Comments on CIP_B3 By CCS

1. Comments on 2.3 in CIP_B3

Figure 1

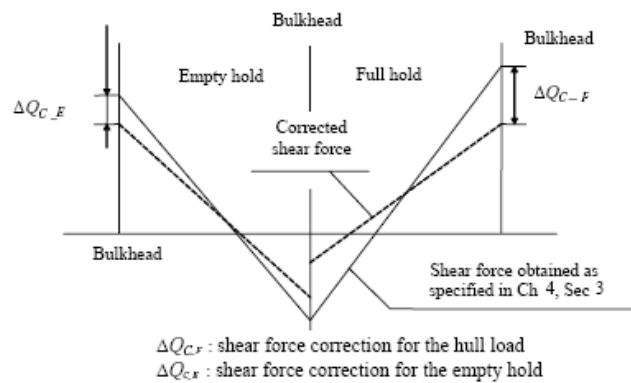
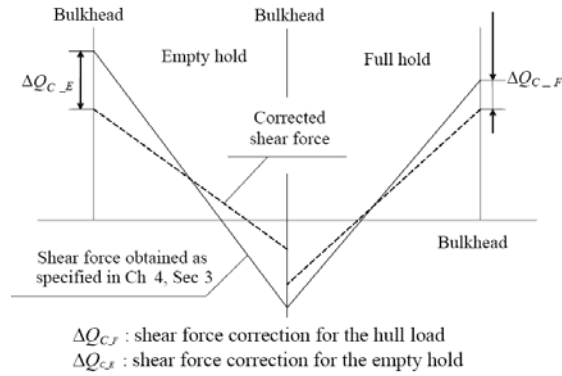
2. Comments on Figure 1 in CIP_B3

CCS Comment

Figure 1 should be changed as following because $\Delta Q_{C,E}$ is bigger than $\Delta Q_{C,F}$ generally.

Figure 3

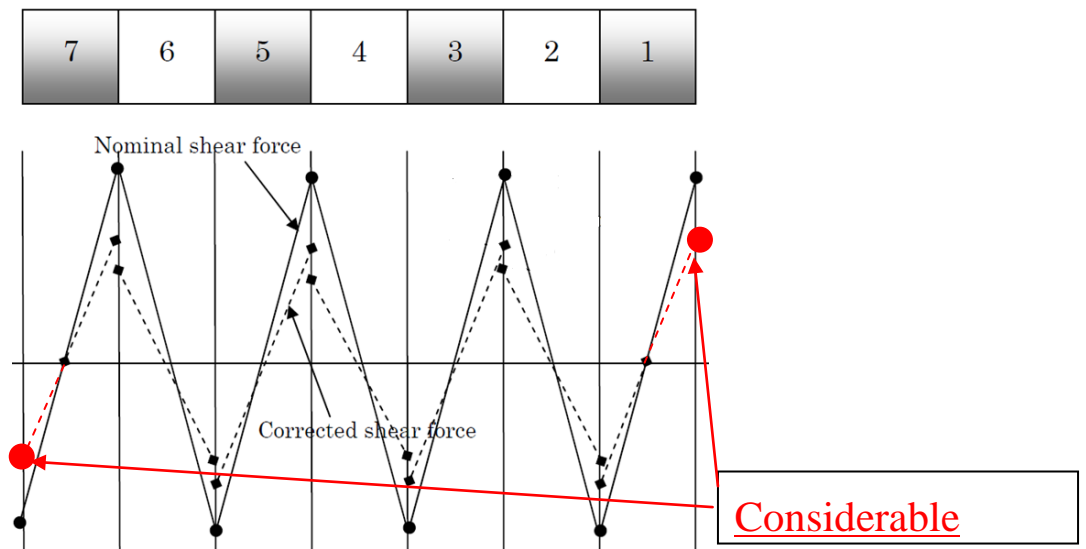
3. Comments on Figure 2 in CIP_B3

CCS Comments

Based on a verification study by FEM, as shown in the appendix A, the shear force correction need to be considered at the fore end of foremost hold and aft end of aftermost hold. But according to the 3rd paragraph in Ch5/Sec1/[2.2.1], the shear force correction need not to be considered at the fore end of foremost hold and aft end of aftermost hold. The rule change should be considered as following:

~~The shear force correction ΔQ_c is to be taken into account, in accordance with [2.2.2]. The shear force correction need not to be considered at the fore end of foremost hold and aft end of aftermost hold.~~

Figure 4

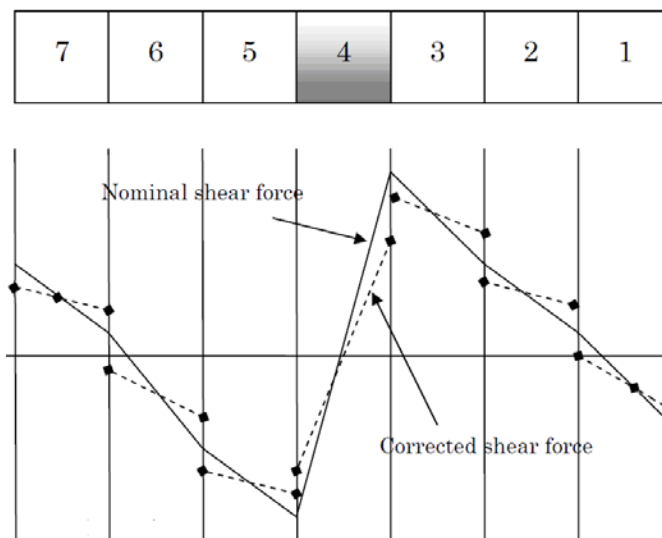
4. Comments on Figure 3 in CIP_B3

CCS Comments

1. Based on a verification study by FEM, as shown in the appendix A, the shear force correction should always be taken into account for every hold.
2. For BC-B and BC-C ships, the shear forces in heavy ballast condition are generally larger than those in other loading conditions. So the shear force correction should be considered for every hold in heavy ballast condition.
3. Regarding homogenous loading condition, the shear force correction can be ignored because it is little.

Figure A-2

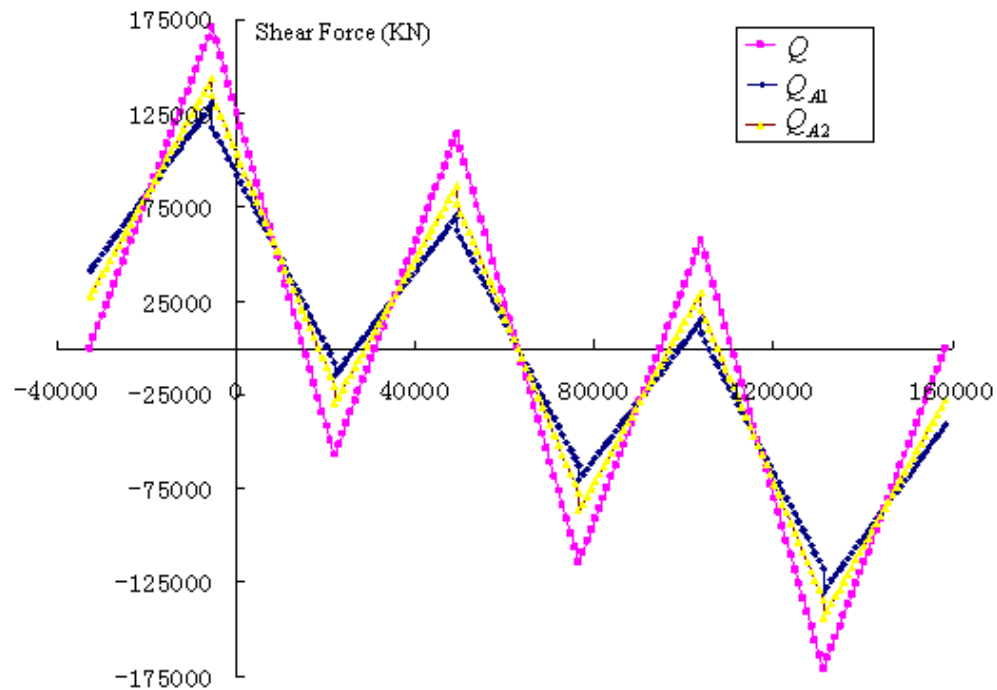
All results of Q_{A1} was linear fitted using least square approach. The comparisons among Q , Q_{A1} , and Q_{A2} are shown in Figure A-2 and Figure A-3.

The shear force correction phenomena will always take place, and the shear force correction need to be considered at the fore end of foremost hold and aft end of aftermost hold.
